MASTER DEVELOPMENT PLAN

AMBER CREEK

Re: Amber Creek Subdivision

Master Development Plan, **MDP # 038-06**

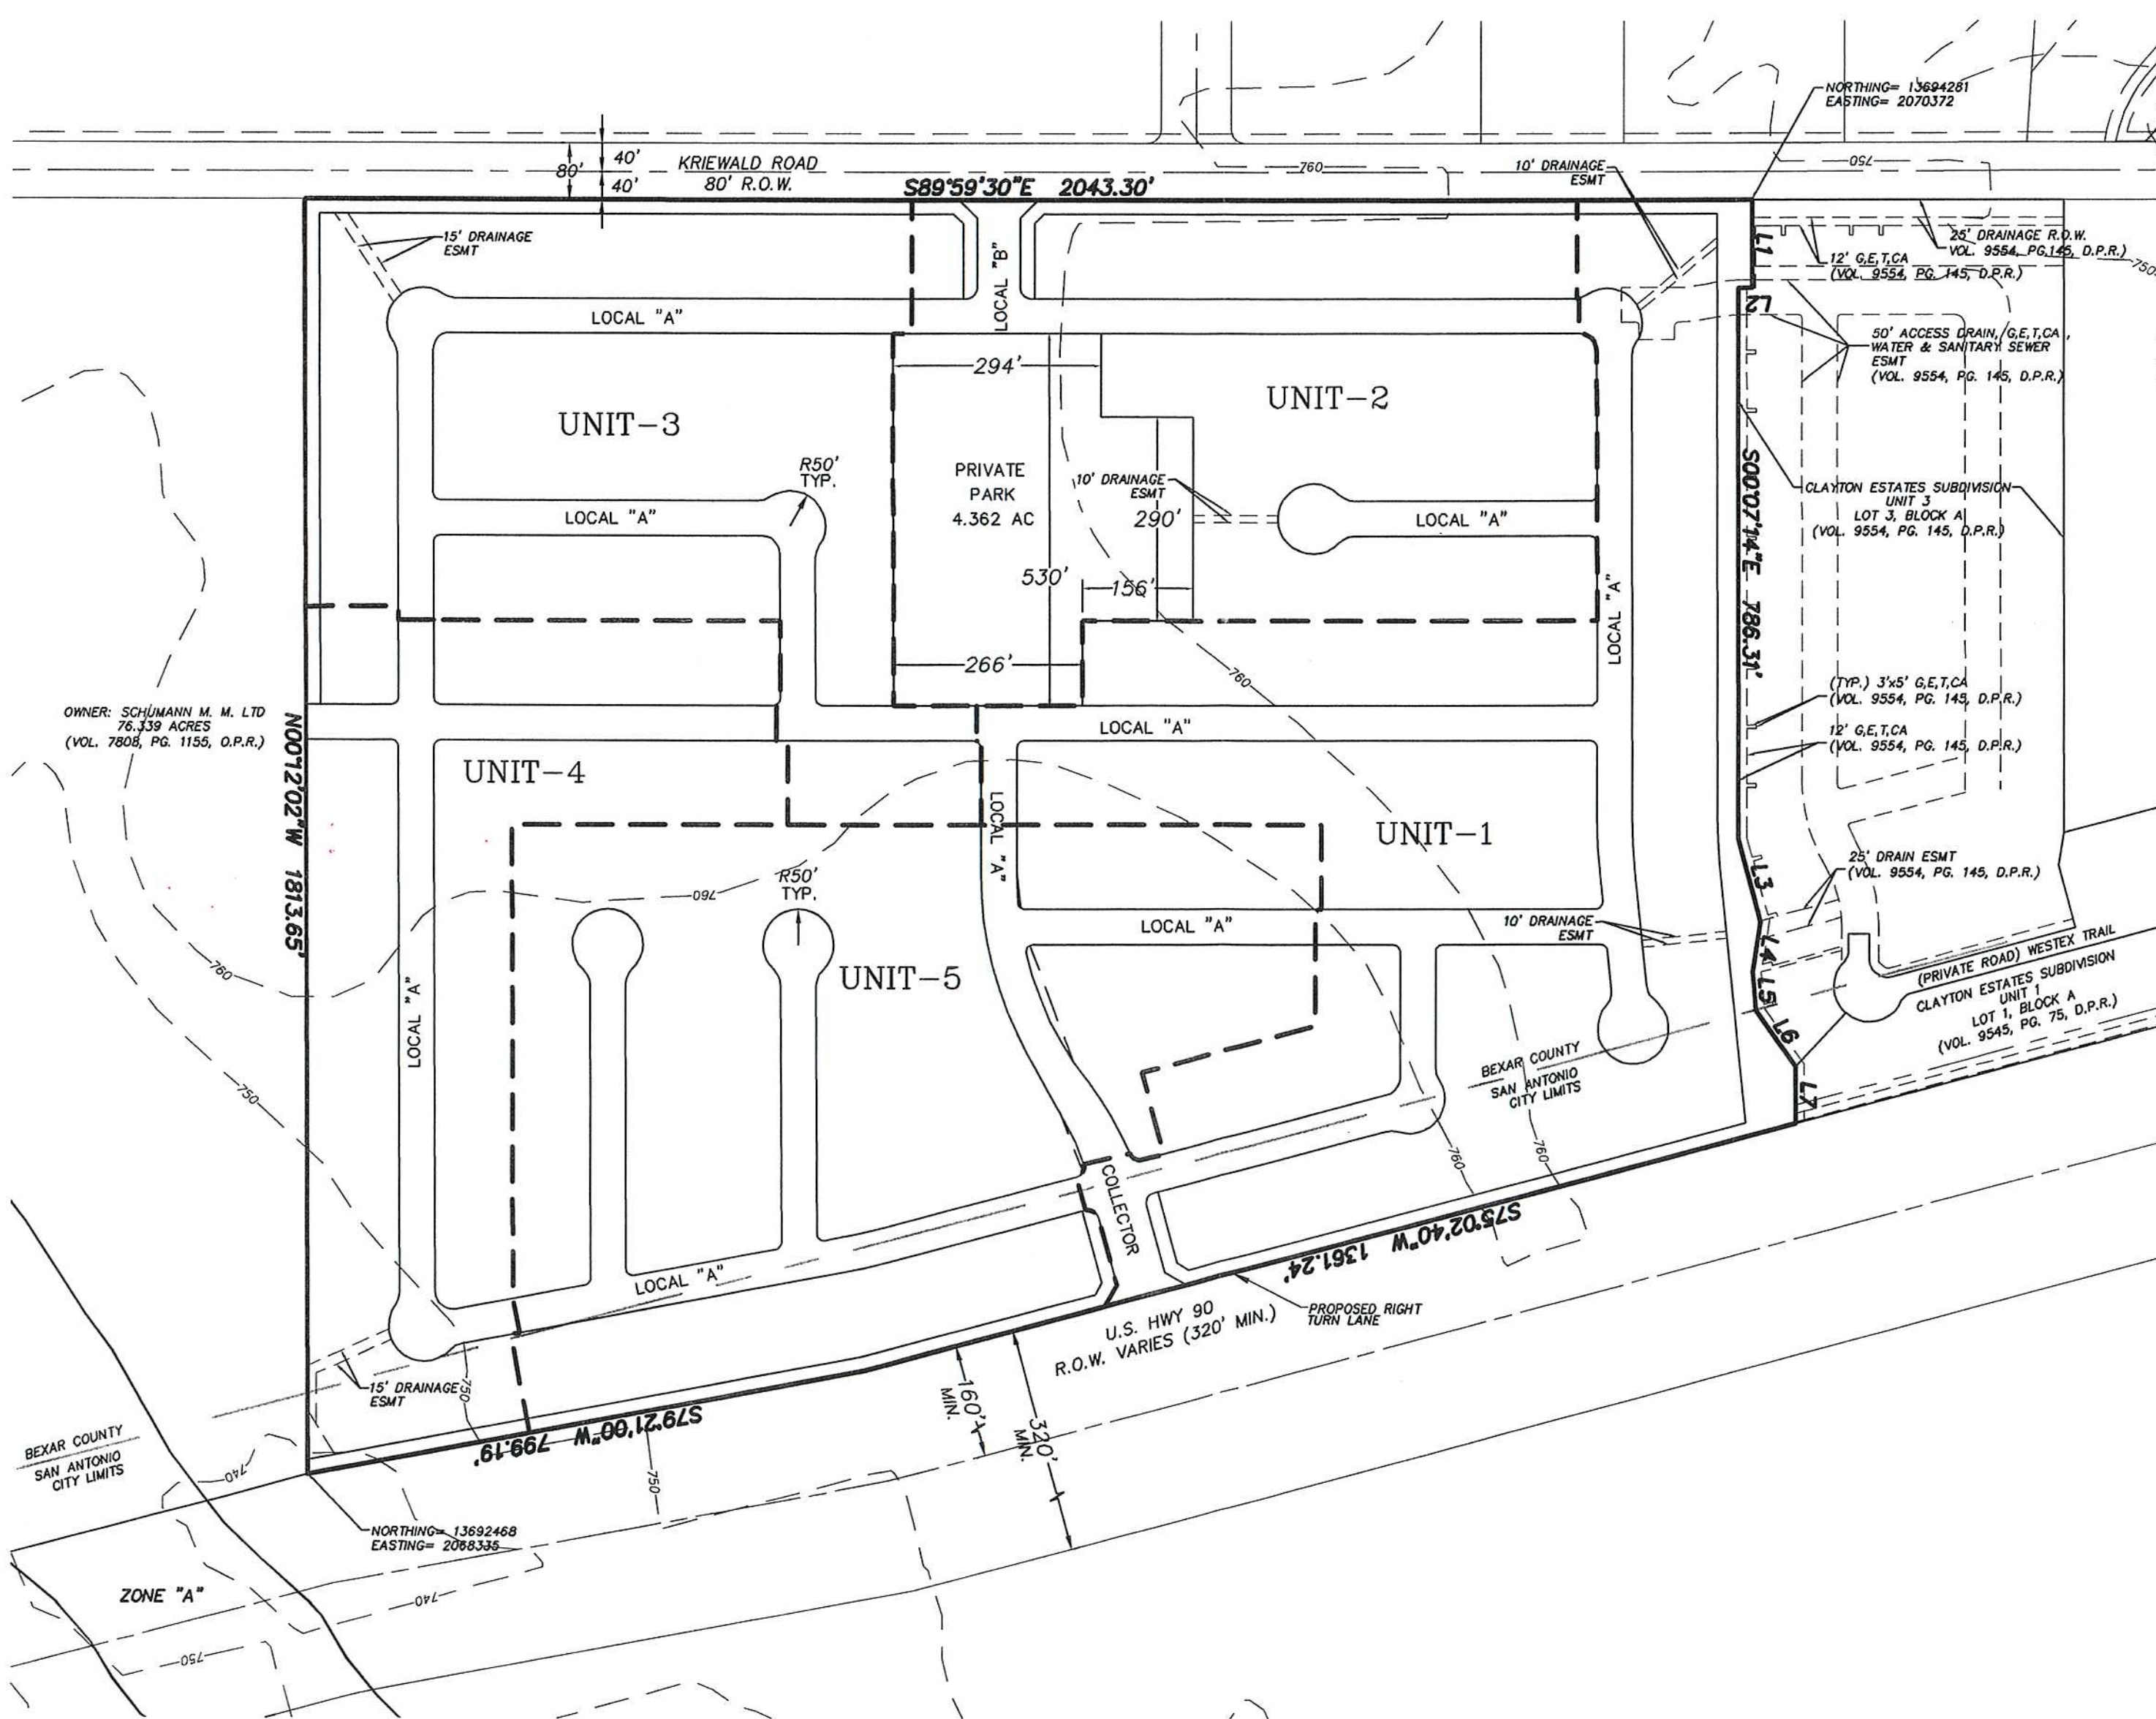
In consideration of public safety and convenience, excessive grades by reason of topography should be avoided in street layouts and arrangements.

DSD – Traffic Impact Analysis & Streets indicates the following requirements and on-site improvements are necessary and shall be provided by the developer, on and before the completion of Amber Creek Subdivision MDP, at no cost to the City of San Antonio.

- All roadways shall follow Table 506-7, Functional Classification System Description and shall comply with UDC 35-502(a)(9).

- All access roadways shall provide clear sight distance on all existing and proposed roadways in order to provide adequate obstruction free viewing distances for approaching traffic. All signage, landscaping, and improvements shall be selected and located so as to not block these clear sight distance areas.
- All sidewalks shall comply with UDC 35-506(q).
- Need to coordinate with County (CIP Division) for improvements on Kriewald Rd.

Parks and Recreation recommends approval of Amber Creek Master Development Plan with the following conditions:

- The parkland provided shall be shown as "Park" or "Open Space" on a plat; UDC section 35-503(e) *Designation of Parkland*.
- The parkland provided is dedicated to the Home Owners Association.
- The instruments creating the Home Owners Association are provided by the second application for plat approval; UDC section 35-503(e) *Designation of Parkland*.
- Parkland dedication must be platted by the second phase of residential development; UDC section 35-503(f) *Development Phasing*.
- All amenities provided shall comply with standards and specifications found in UDC section 35-503(h) *Credit for Park Facilities* and Table 503-4 if any credit is to be awarded.
